PENZONE BASE ONE

AMENDED FINAL DEVELOPMENT

OCTOBER 20TH, 2023

EXTERIOR PAINT OPTIONS

Northeast Elevation

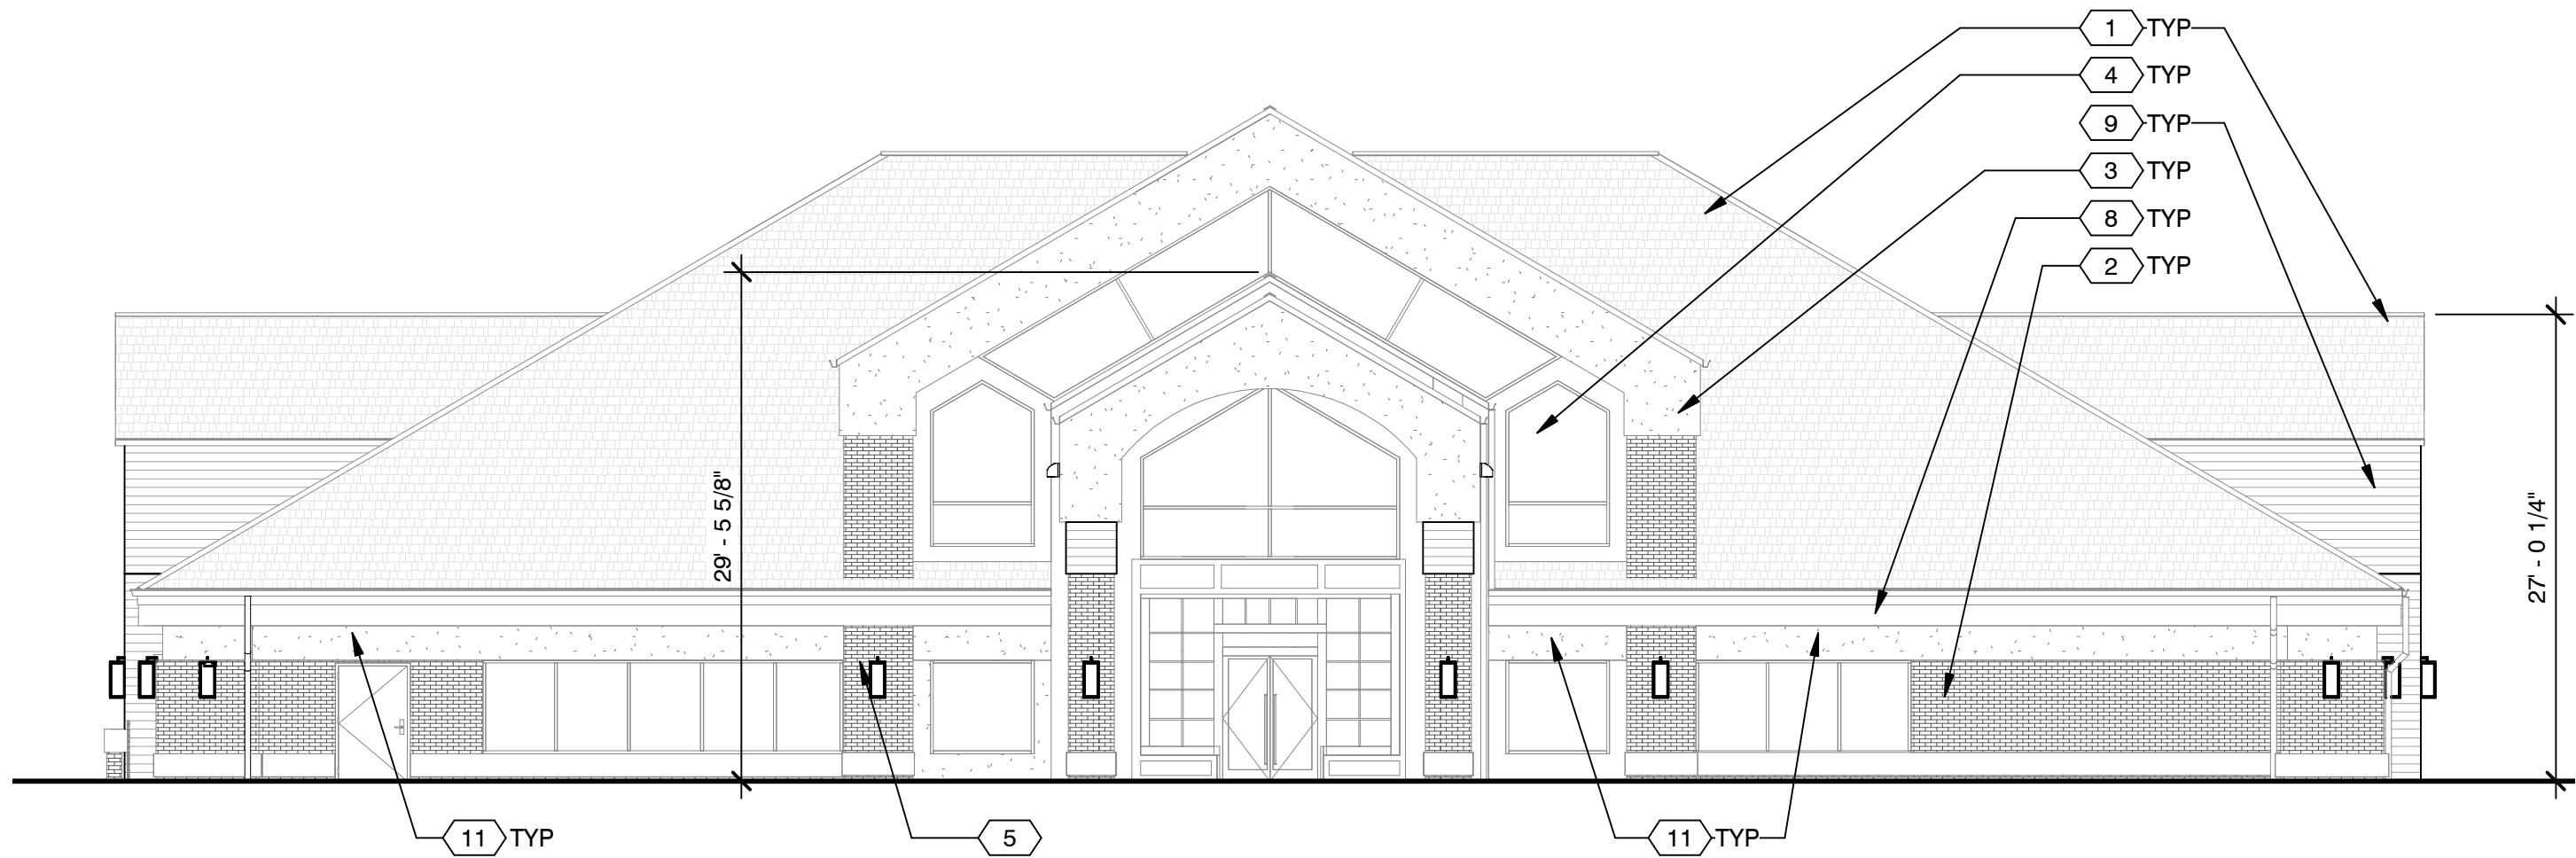
- 2 EXISTING BRICK - PAINT SW 7627 WHITE HERRON
- 3 EXISTING STUCCO - REPAINT. COLOR SW 7030 ANEW GRAY
- 8 FASCIA TO BE PAINTED w. SW 7627 WHITE HERRON
- 11 SOFFIT. PAINT COLOR SW 7019 GAUNTLET GRAY

Southwest Elevation

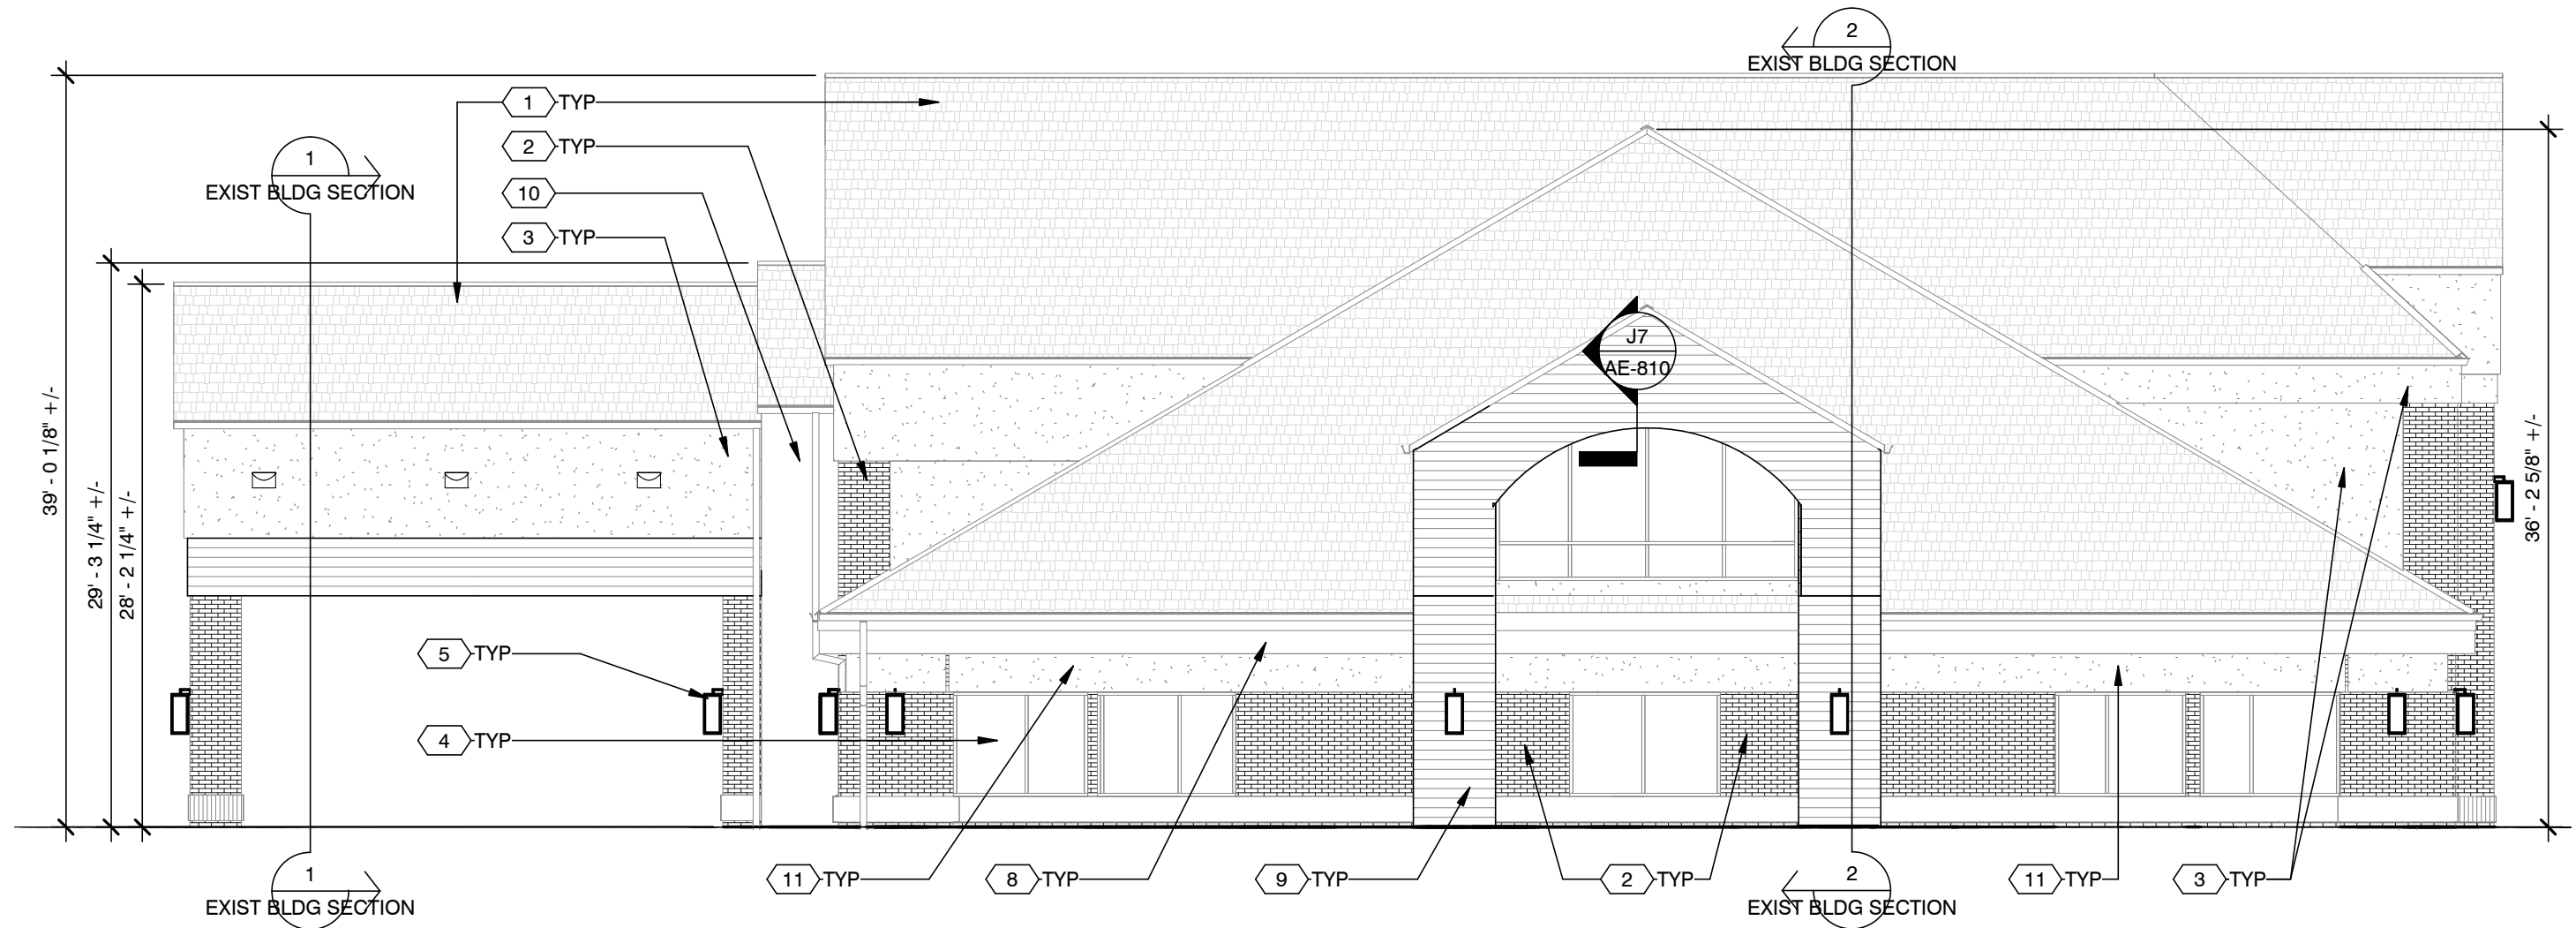
- 2 EXISTING BRICK - PAINT SW 7627 WHITE HERRON
- 3 EXISTING STUCCO - REPAINT. COLOR SW 7030 ANEW GRAY
- 8 FASCIA TO BE PAINTED w. SW 7627 WHITE HERRON
- 11 SOFFIT. PAINT COLOR SW 7019 GAUNTLET GRAY

Southeast Elevation

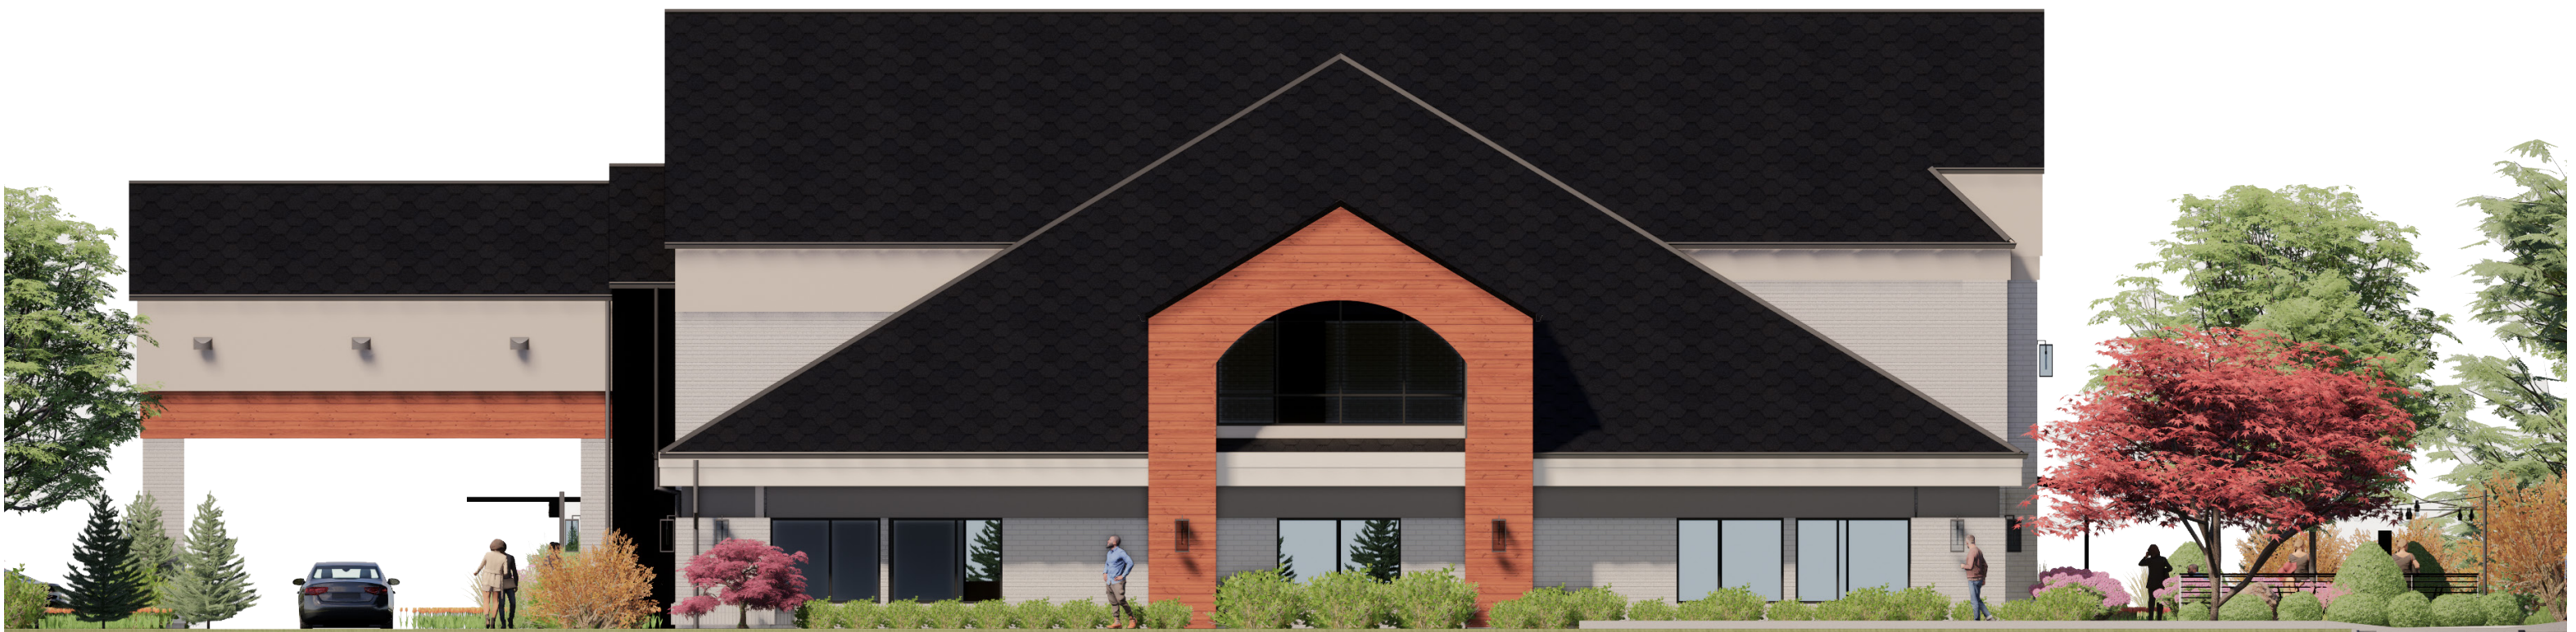
- 2 EXISTING BRICK - PAINT SW 7627 WHITE HERRON
- 3 EXISTING STUCCO - REPAINT. COLOR SW 7030 ANEW GRAY
- 8 FASCIA TO BE PAINTED w. SW 7627 WHITE HERRON
- 11 SOFFIT. PAINT COLOR SW 7019 GAUNTLET GRAY

Northwest Elevation

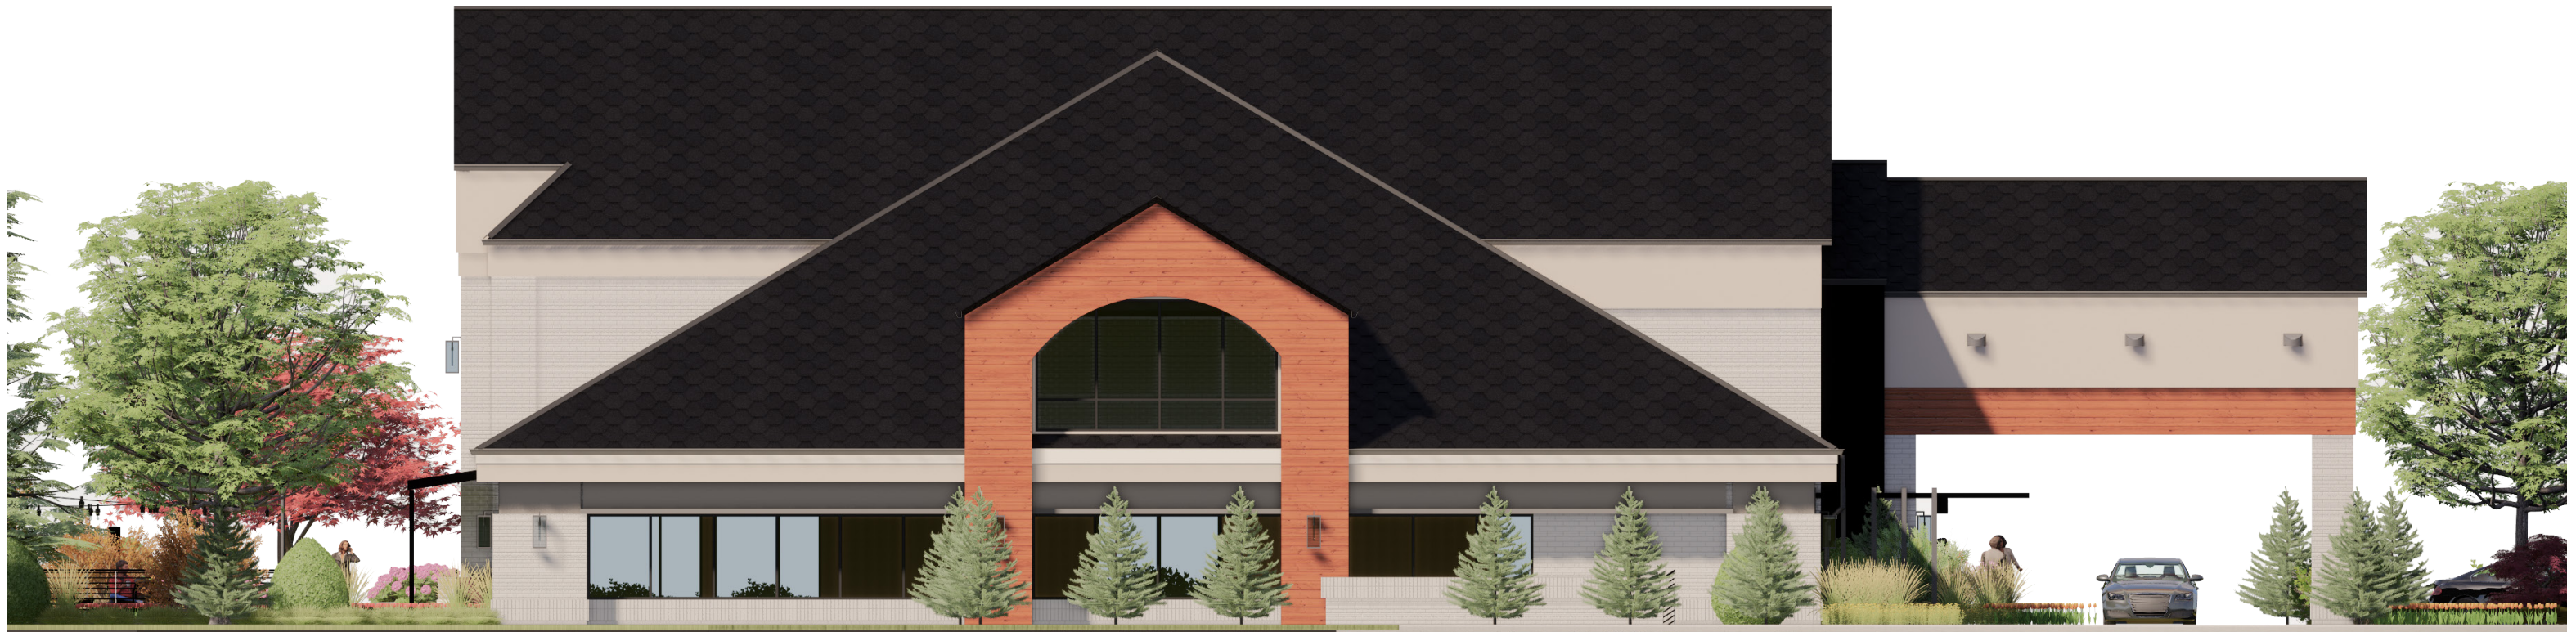
- 2 EXISTING BRICK - PAINT SW 7627 WHITE HERRON
- 3 EXISTING STUCCO - REPAINT. COLOR SW 7030 ANEW GRAY
- 8 FASCIA TO BE PAINTED w. SW 7627 WHITE HERRON
- 11 SOFFIT. PAINT COLOR SW 7019 GAUNTLET GRAY

EXTERIOR PAINT APPLICATION

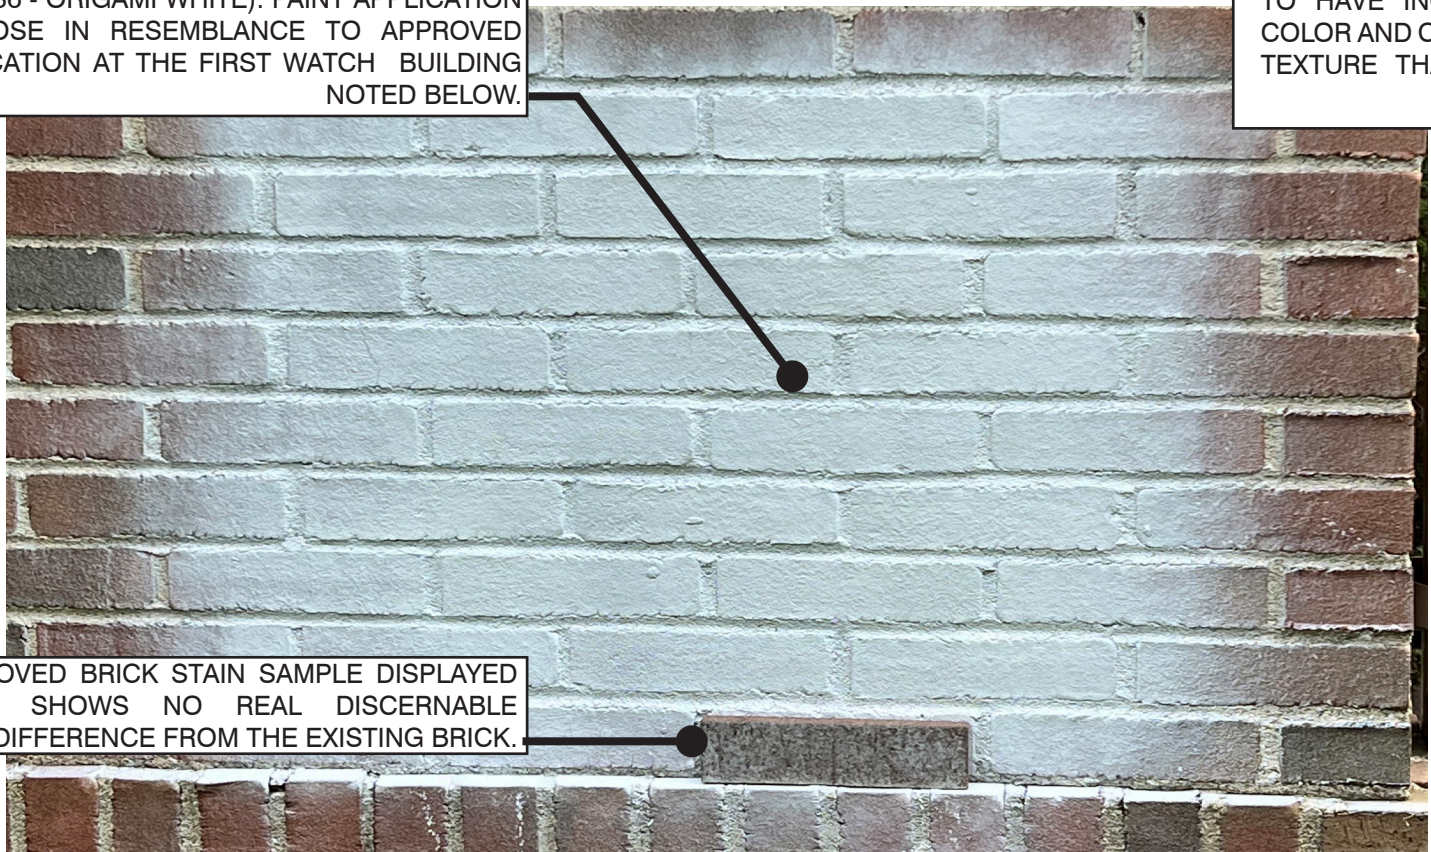
MOCKUP OF PROPOSED PAINTING OF BRICK (SW7636 - ORIGAMI WHITE). PAINT APPLICATION IS CLOSE IN RESEMBLANCE TO APPROVED APPLICATION AT THE FIRST WATCH BUILDING NOTED BELOW.

CURRENT APPLICATION OF STAIN IS PROVING TO HAVE INCONSISTENCIES BETWEEN BRICK COLOR AND CURRENT STATE OF BRICK PHYSICAL TEXTURE THAT ALTERS THE ABSORPTION OF STAIN AND FINAL APPEARANCE.

RECENTLY APPROVED BRICK PAINT APPLICATION

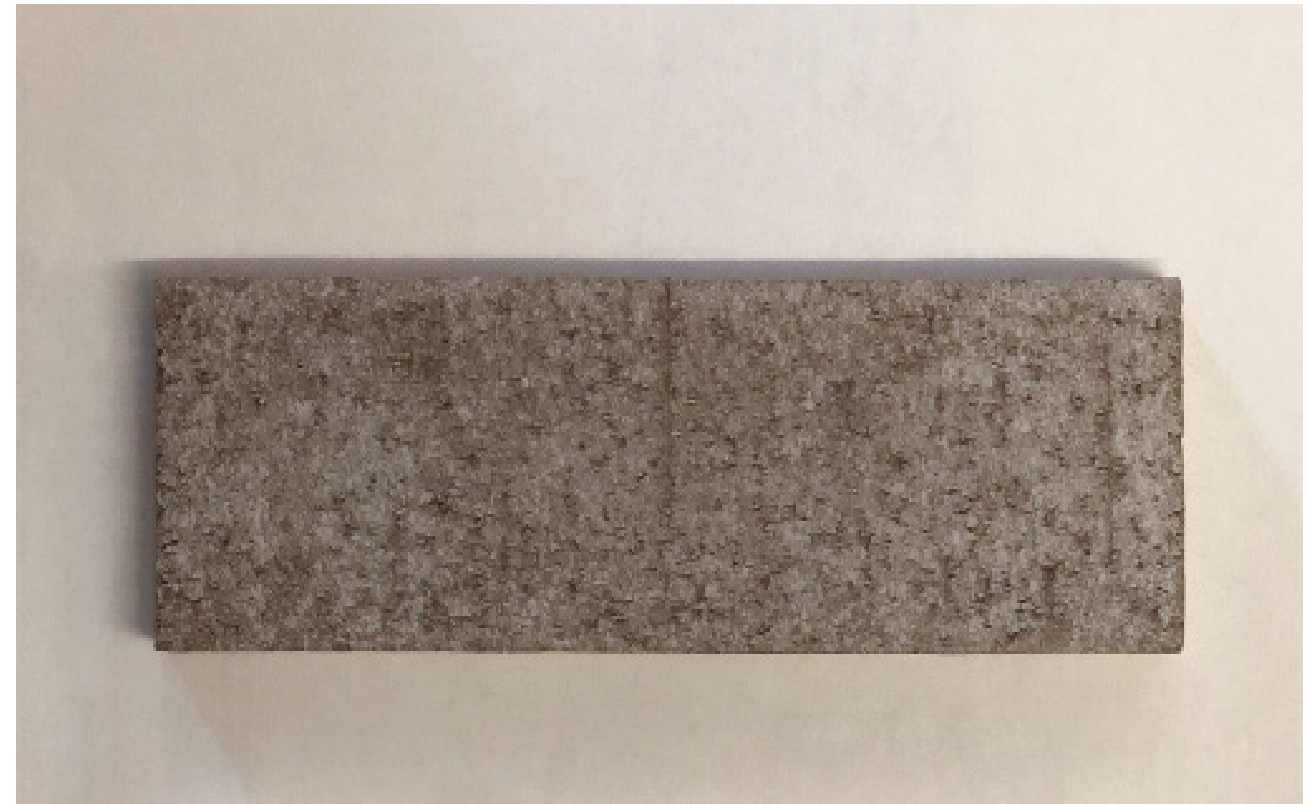
APPROVED BRICK STAIN SAMPLE DISPLAYED HERE SHOWS NO REAL DISCERNABLE DIFFERENCE FROM THE EXISTING BRICK.
